USEPA TRANSMITTAL INFORMATION FOR  
HYDE PARK/BLOODY RUN DOCUMENTS

Description of Attachment: LETTER OF AUGUST 13, 1984 FROM J. NICTER (OCC) to N. NOSENCHUCK (NYS DEC) and J. SPATOLA (USEPA) REGARDING: Hyde PARK REMEDIAL PROJECT - PERMANENT LEACHATE STORAGE AND HANDLING FACILITY.

Subject: Hyde Park Remedial Project -- Permanent Leachate Storage and Handling Facility

Hyde Park Remedial Program: Permanent Leachate  
Storage and Handling Facility - OCC Response to  
EPA/State Comments, Dated May 2, 1984

## CAPACITY OF CONTAINMENT AREA FOR HYDE PARK STORAGE

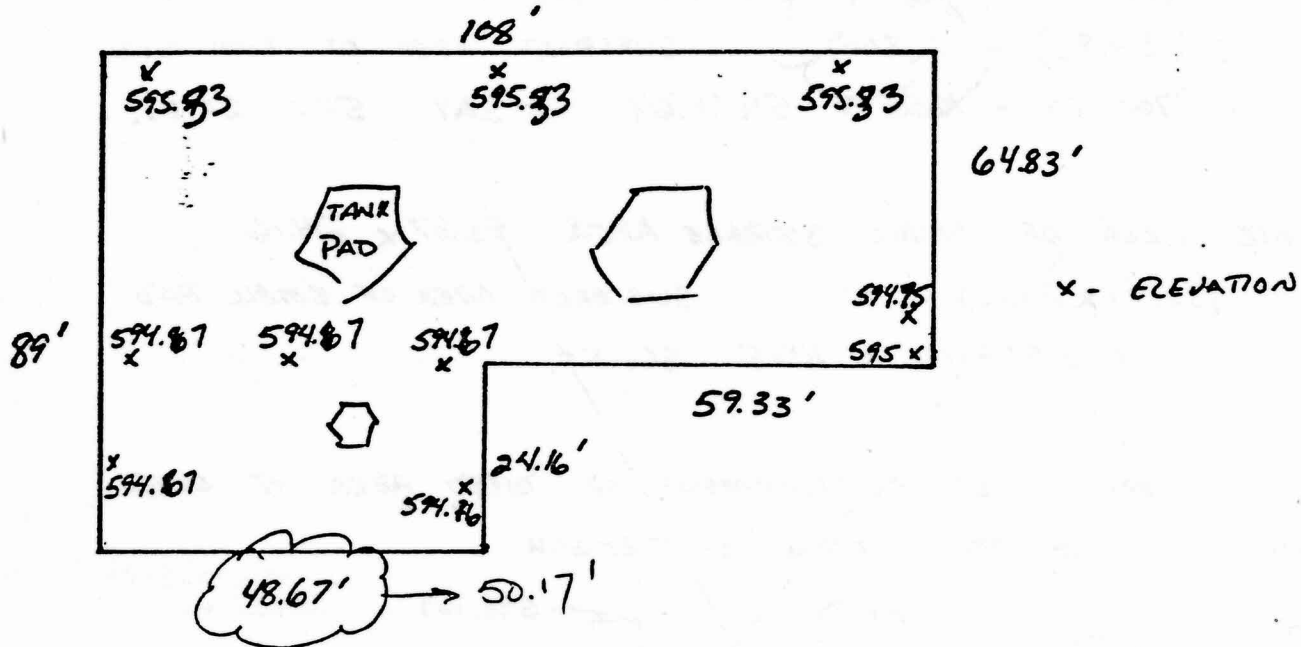
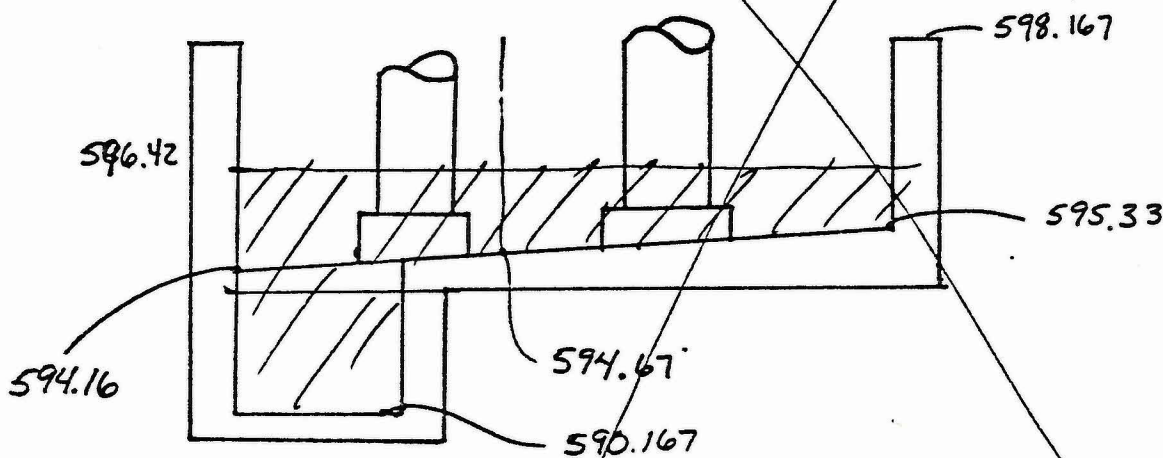
I have reviewed the information which you recently gave me regarding containment volume, for the Hyde Park Leachate Storage Facility and I have the following comments:

1. The elevations provided by OCC on their 12/83 computation sheets do not agree with the elevations provided on plan sheets A-11-17915 through A-11-17925. OCC should advise which elevations are to be used. If the calculation sheet elevations are correct, revised plans should be submitted.

2. I feel that a 100 year 24-hour storm plus the volume of the largest tank should be contained by the facility. At a minimum, a 10 year 24-hour storm plus the volume of the largest tank should be contained below the top of the trench in the Loading Pad/Wash Building. As can be seen on sheet 8 of 8 (attached calculations), neither of these design conditions are met by the data that has been supplied to our office (plan sheets or computation sheet - see 1 above).

Comments, (Pg 1) 48.67' dimension should be 50.17'

(Pg 2 thru 4) Don't use Dwg. Elevs, They are incorrect.  
Use Elevs per attached OCC Calc. Sheet 10.

(Pg 2) Only (i) tank volume should have been deducted

(Pg 8) Corrected Dike Volume is now 197,000 gals  
which is close to OCC's calculated 198,416 gal

Should only be (1) tank deducted.
